REVISION	DATE	REVISED DETAIL #1	RT
11/25/92			SY
NORMAN ENGINEERING CO.		DEPARTMENT OF THE ARMY	
CONSULTING ENGINEERS		SACRAMENTO DISTRICT, CORPS OF ENGINEERS	
LOS ANGELES, CALIFORNIA		SACRAMENTO, CALIFORNIA	
DESIGNED BY	MCCLELLAN AIR FORCE BASE CALIFORNIA		
R. SHEPARD	ADAL DEPOT CORROSION CONTROL FACILITY		
DRAWN BY	NEW AIRCRAFT PAINT FACILITY		
R. TAGAYUN			
CHECKED BY	GROUNDING PLAN B/B		
L. MYERS			
SUBMITTED BY	DATE APPROVED	SCALE: 1/16" = 1'-0"	SPEC No. 8529
9/30/92			
SHEET E-5		FILE No.	100-25-2051
77 OF 95

COLLINS ELECTRICAL CO., INC. 4107 Northgate Blvd. Sacramento, CA 95831 Phone: (916) 557-1100		DESIGNED BY R. SHEPARD		DRAWN BY R. TAGAYUN		CHECKED BY L. MYERS		SUBMITTED BY [Signature]	
DATE 9/30/92		DESCRIPTION NEW AIRCRAFT PAINT FACILITY		PROJECT ADAL DEPOT CORROSION CONTROL FACILITY		SHEET NO. E-8		TOTAL SHEETS 2051	
NORMAN ENGINEERING CO. CONSULTING ENGINEERS LOS ANGELES, CALIFORNIA				DEPARTMENT OF THE ARMY SACRAMENTO DISTRICT CORP. OF ENGINEERS SACRAMENTO, CALIFORNIA

FIRST FLOOR POWER PLAN - SOUTH
SCALE: $\frac{1}{8}'' = 1'-0''$

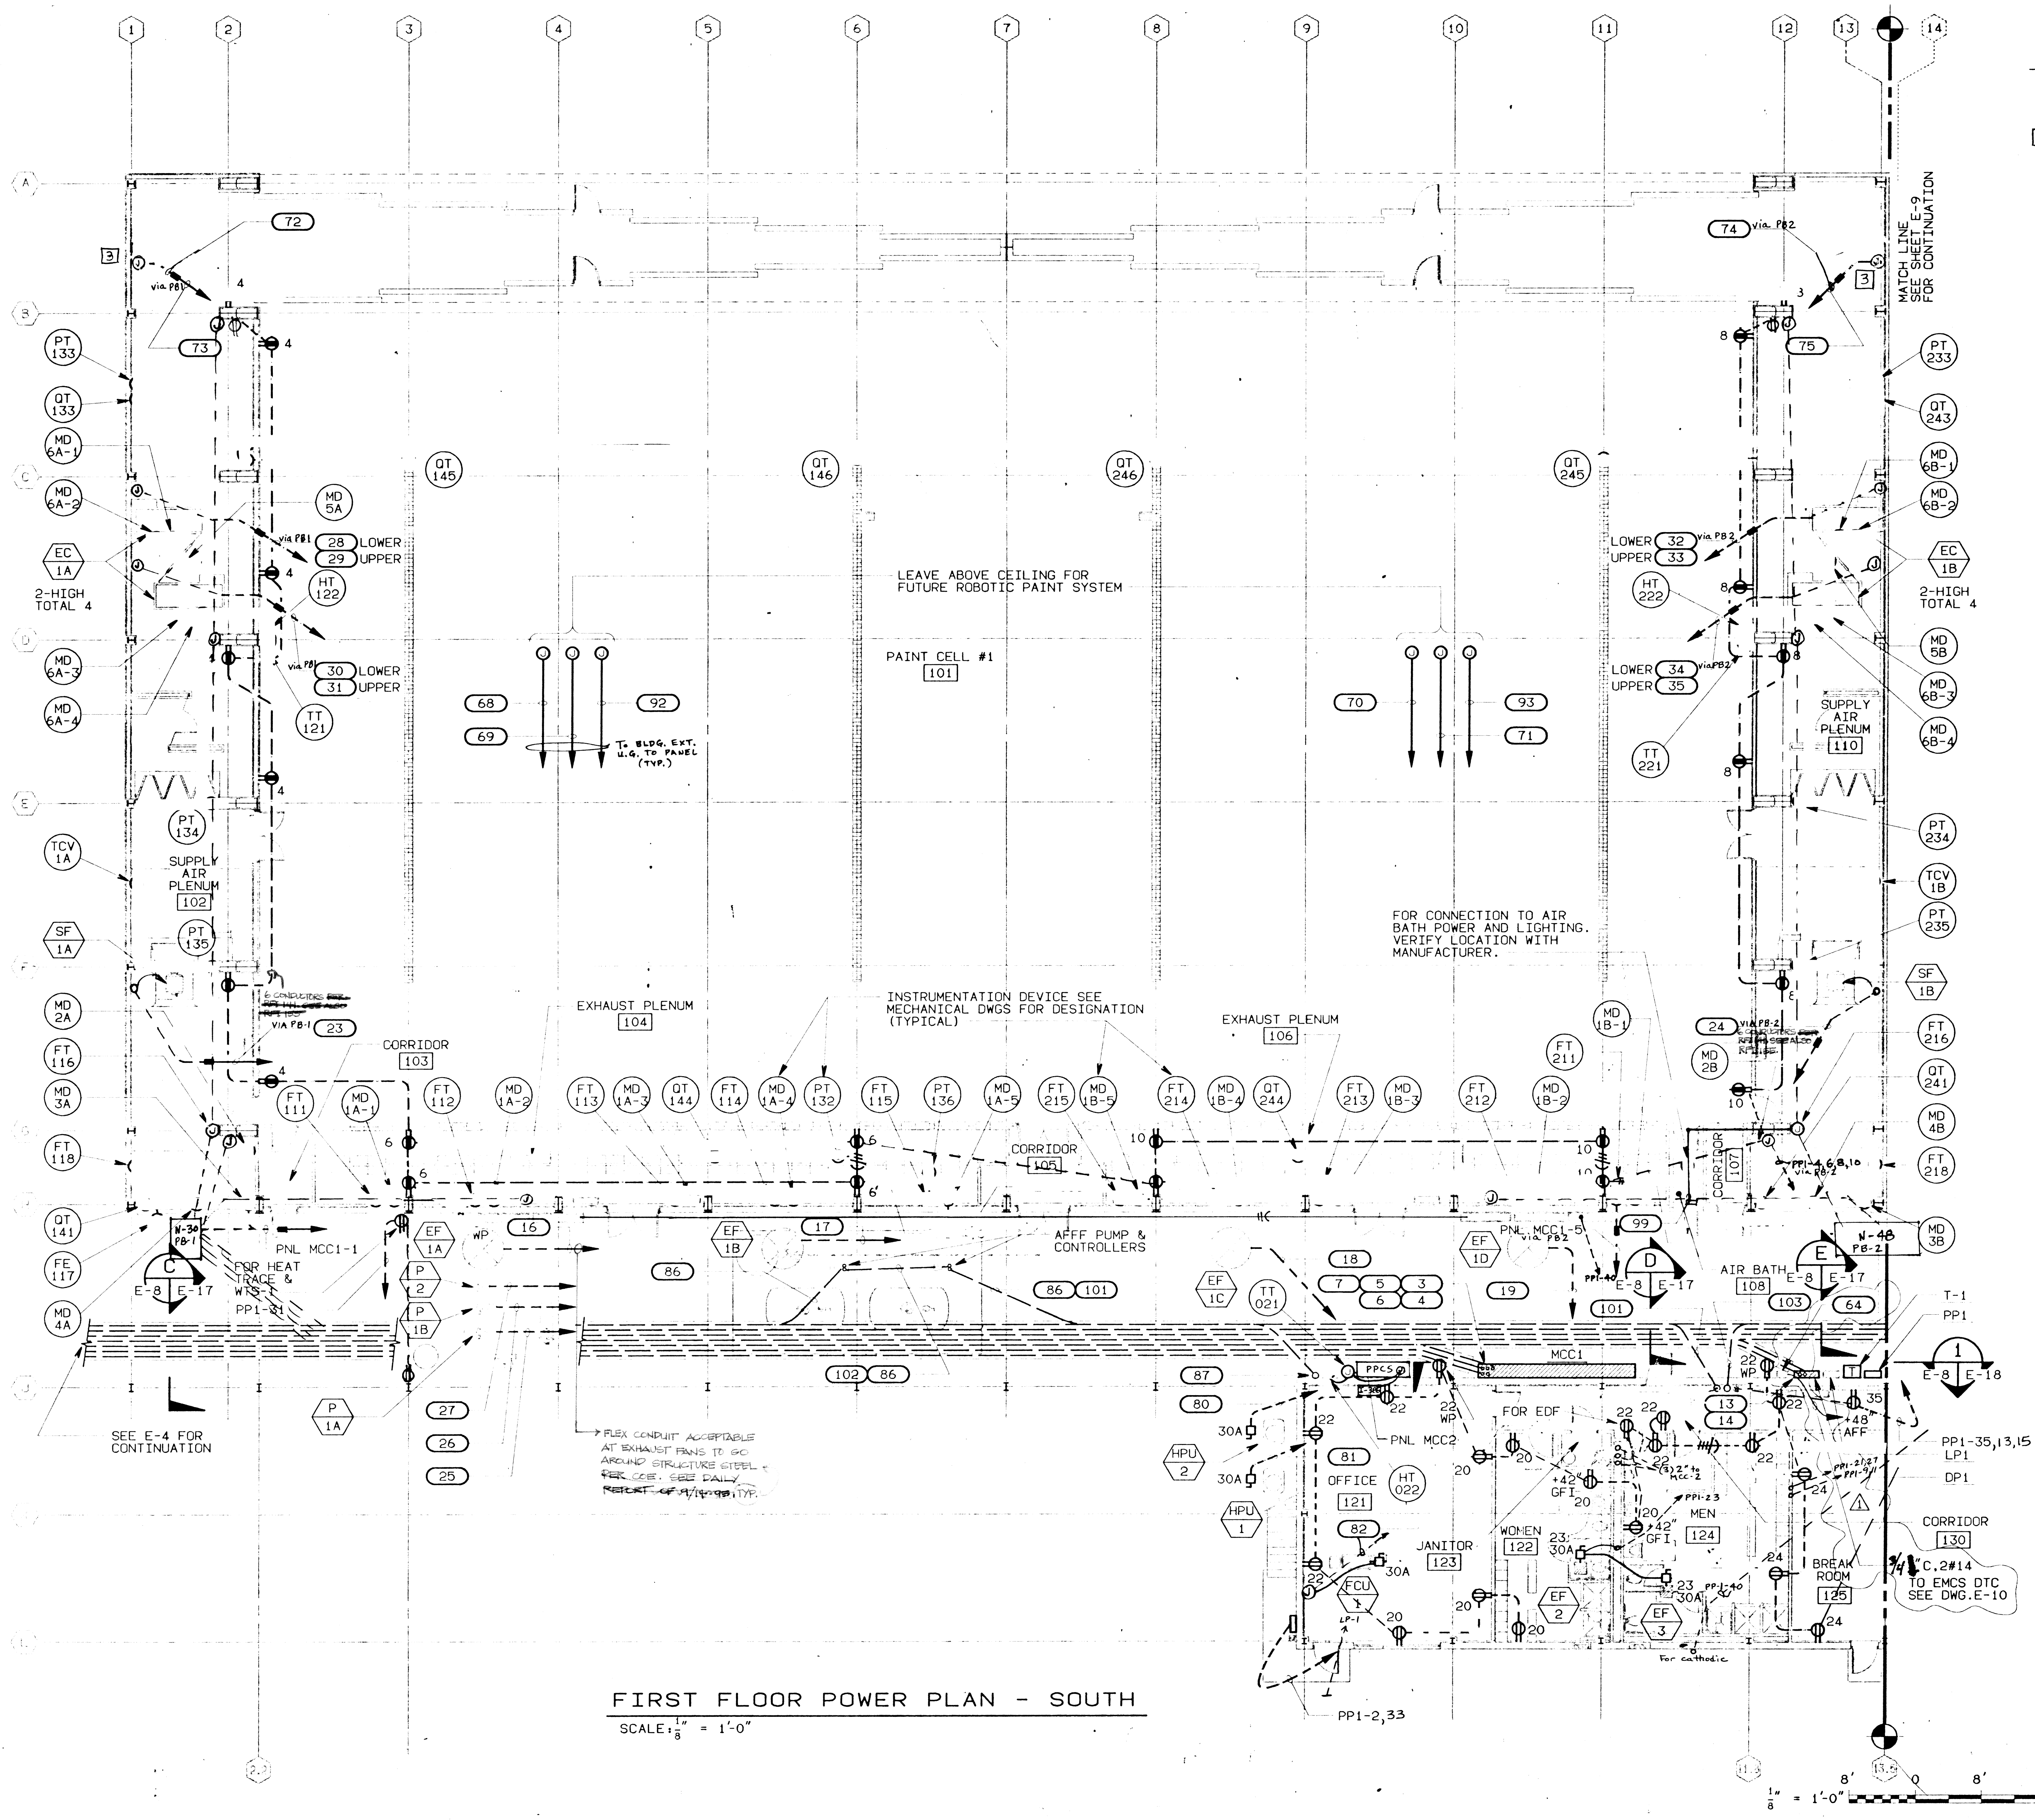
HOMERUNS FROM CLASSIFIED AREAS ROUTED VIA U.G. PULLBOXES OUTSIDE CLASSIFIED AREAS

Both circuits for units FCU-1 and FCU-2 should be fed from the one (1) 20A/2P circuit breaker in panel PPI, circuits 9 and 11 shown on Sheet E-15. The two circuits should be spliced together in panel PPI and then 2#8 AWG from the splice should be run to the 20A/2P circuit breaker. *PP1-23*

MECHANICAL EQUIPMENT SPACE POWER PLAN

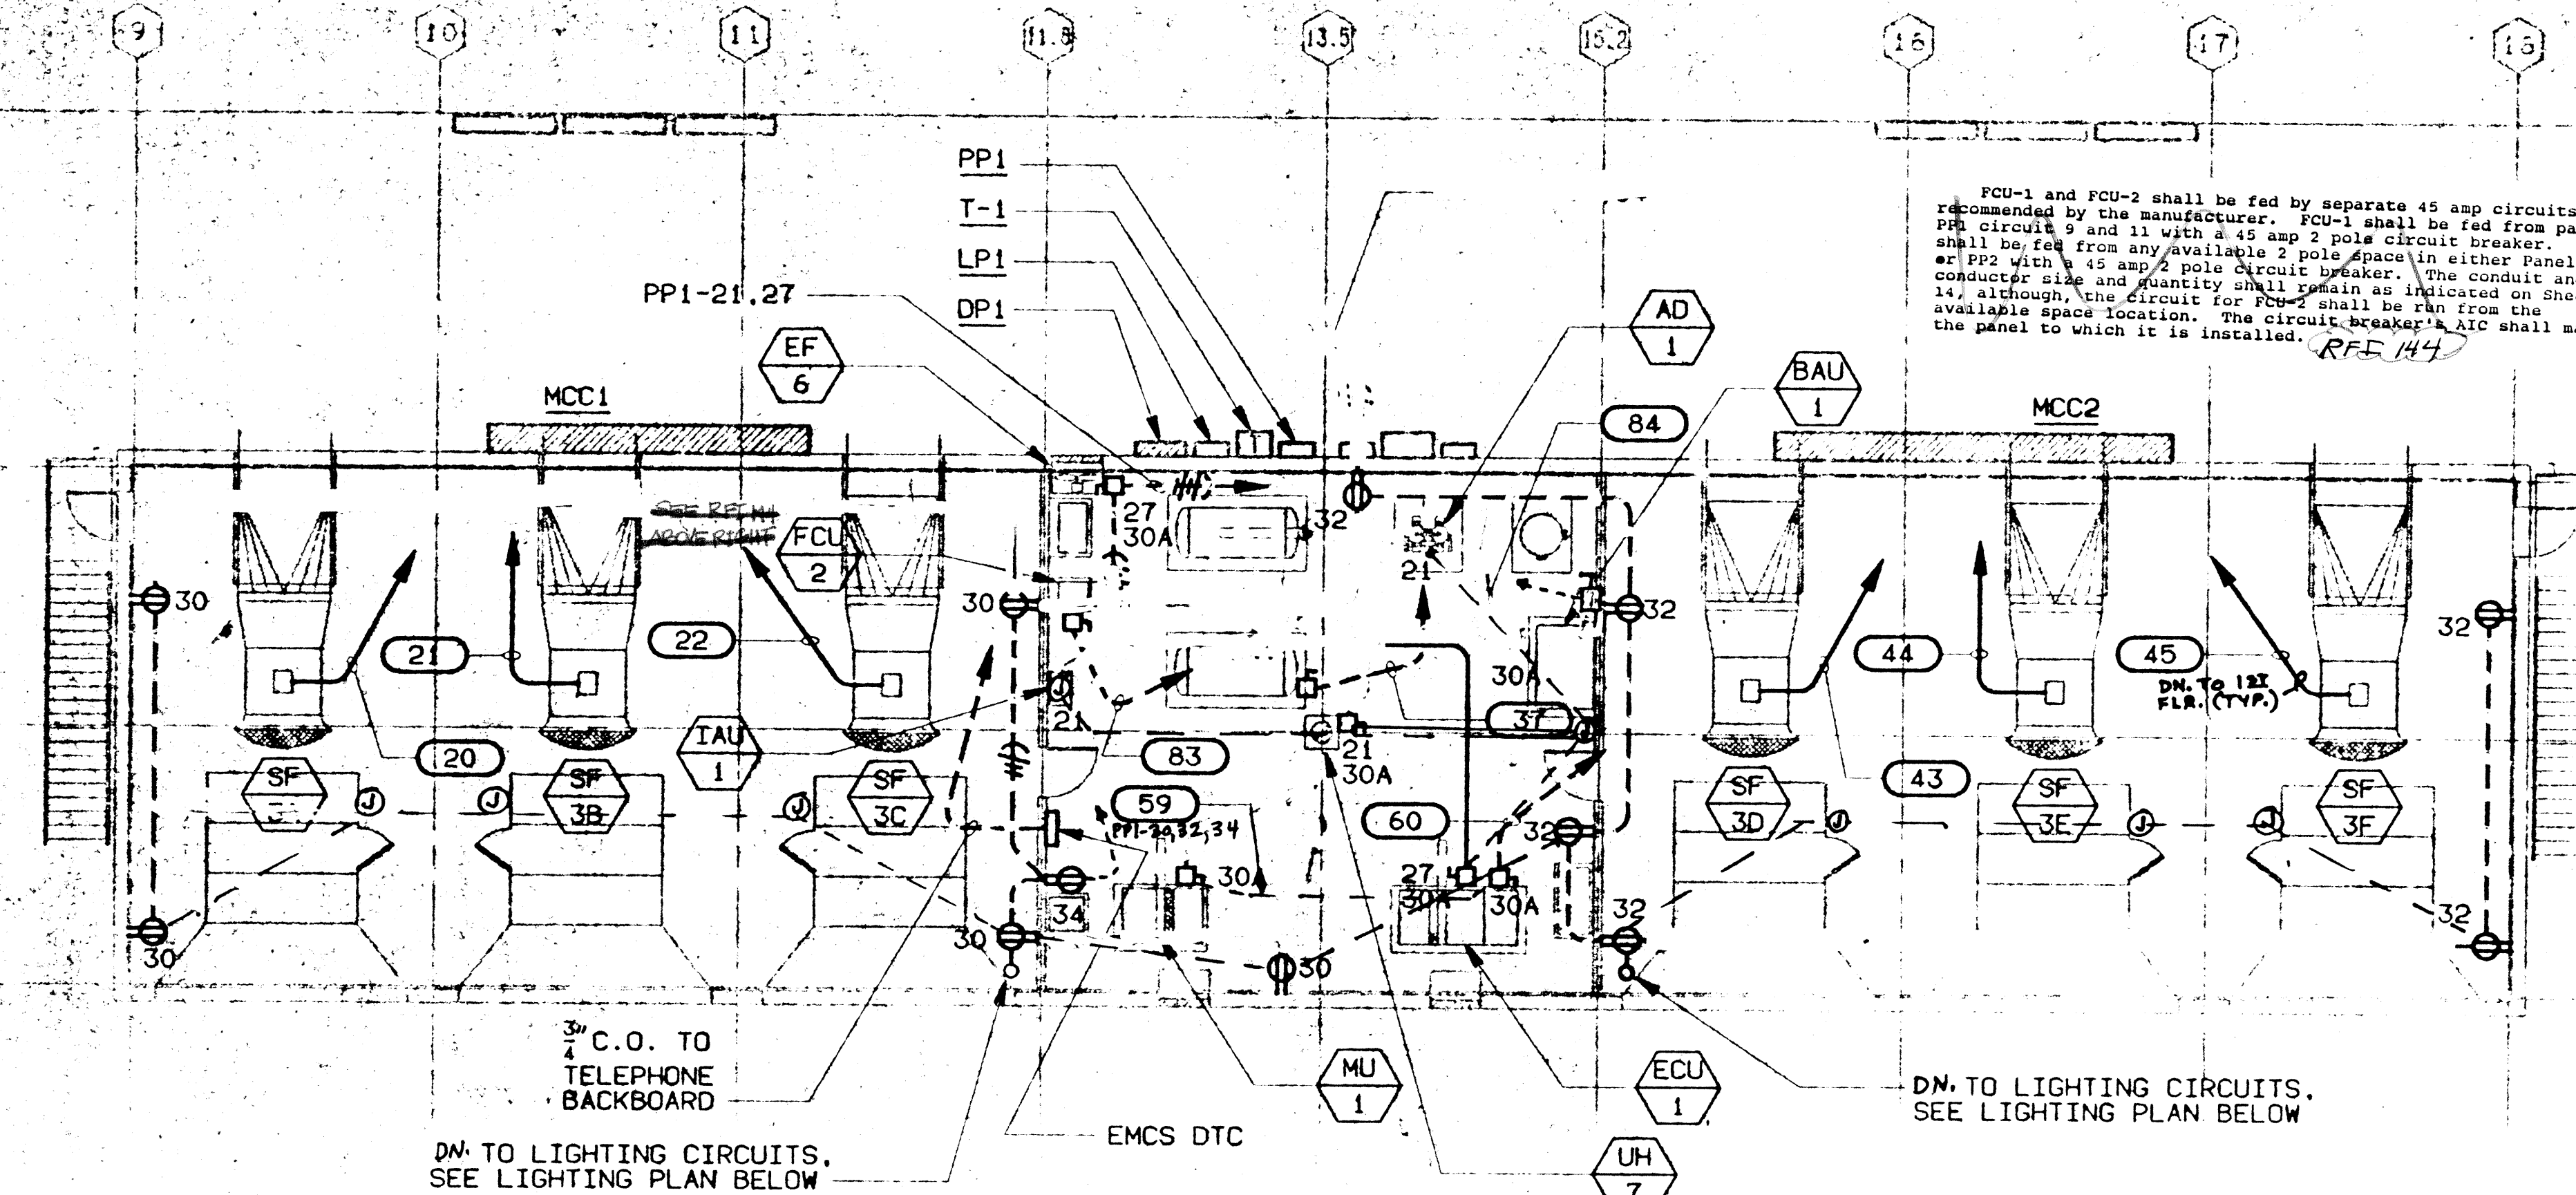
Reference your RPI #92, dated January 19, 1994, regarding the branch circuit conductors running underground in the Class I, Division 1 hazardous area, as defined by the contract drawing sheet E-2. A review of your attached drawing produced the following comments:

Both circuits for units FCU-1 and FCU-2 should be fed from the one (1) 20A/2P circuit breaker in panel PPI, circuits 9 and 11 shown on sheet E-15. The two circuits should be applied together in panel PPI and then 2-#8 AWG from the splice should be run to the 20A/2P circuit breaker.

PROVIDE CONTROLS, DEVICES AND WIRING
MEG. E.Q. AS NEEDED BUT NOT SHOWN PER
RPI #16

- The seal-off located at the conduit stub-up shall be relocated to immediately outside the classified boundary. The seal-off can be located at the adapter between the rigid steel and rigid non-metallic conduit, but there shall be no fittings between the boundary and the seal-off. Reference NEC article 501-5(a)(1).
- All conduit seal-offs shall remain accessible. Reference NEC article 501-5(c)(1).
- Seal-offs will be required within 18 inches of each electrical device that is not factory sealed. Reference NEC article 501-5(a)(1).
- Steel conduit in contact with earth shall be protected against corrosion. Reference specification section 1415 paragraph 3.2.2.1.
- Conduit installed within the slab on grade shall comply with specification section 1415 paragraph 3.2.2.2.
- Conduit crossing a structural joint shall be installed to comply with section 1415 paragraph 3.2.2.

208V-1Ø NON-REVERSING MOTOR

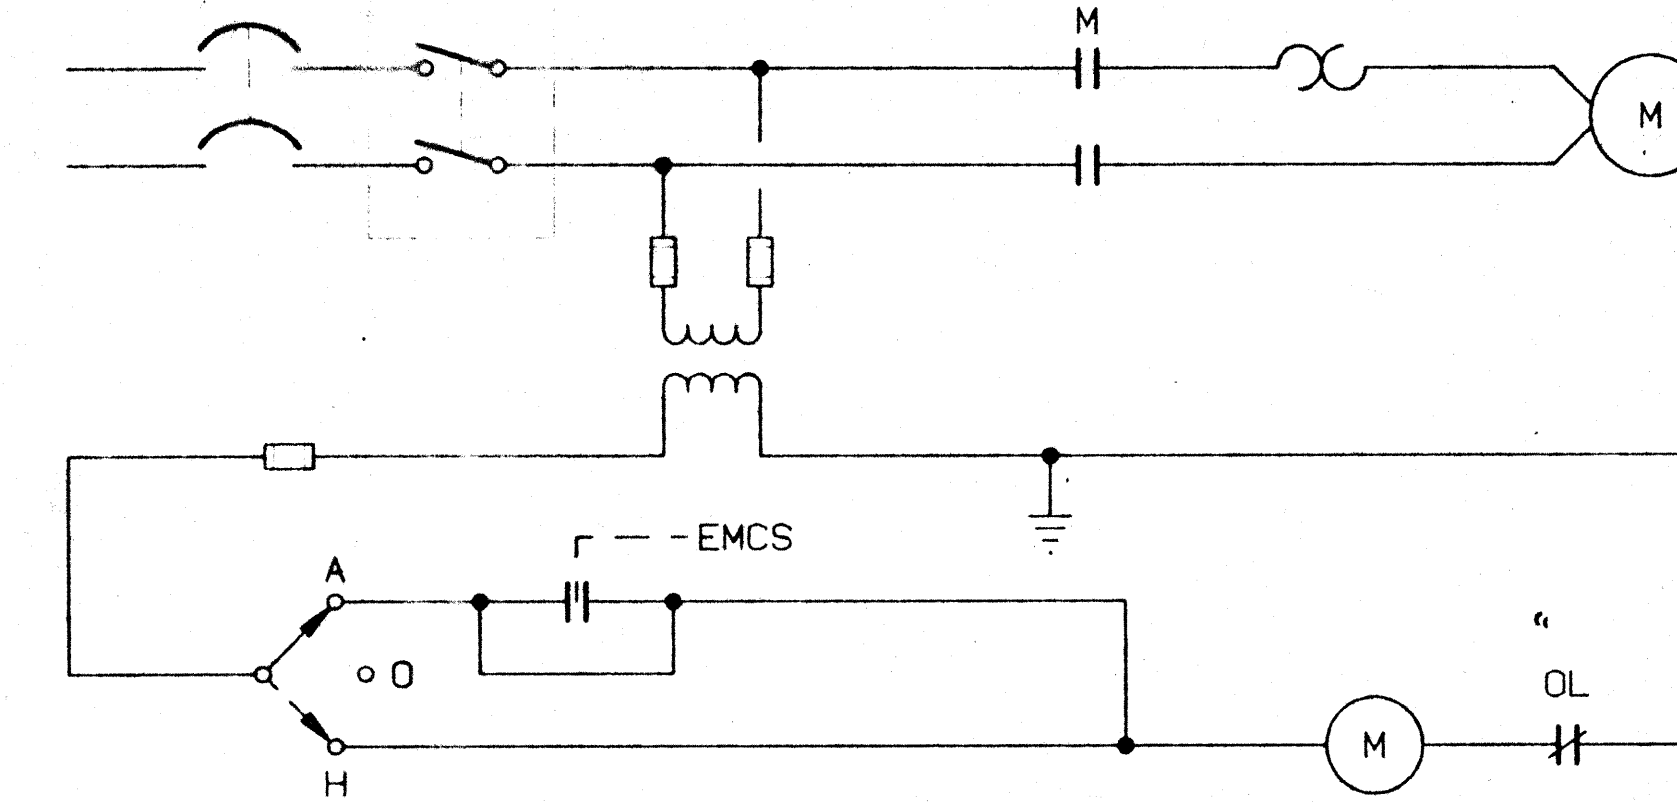
MOTOR	PNL CKT#
FCU-1	PP1-9, 11
FCU-2	PP2-26, 28 PP1-13, 15

Both circuits for units FCU-1 and FCU-2 should be fed from the one (1) 20A/2P circuit breaker in panel PP1, circuits 9 and 11 shown on sheet E-15. The two circuits should be spliced together in panel PP1 and then 2x#14 AWG from the splice should be run to the 20A/2P circuit breaker. RET# 23
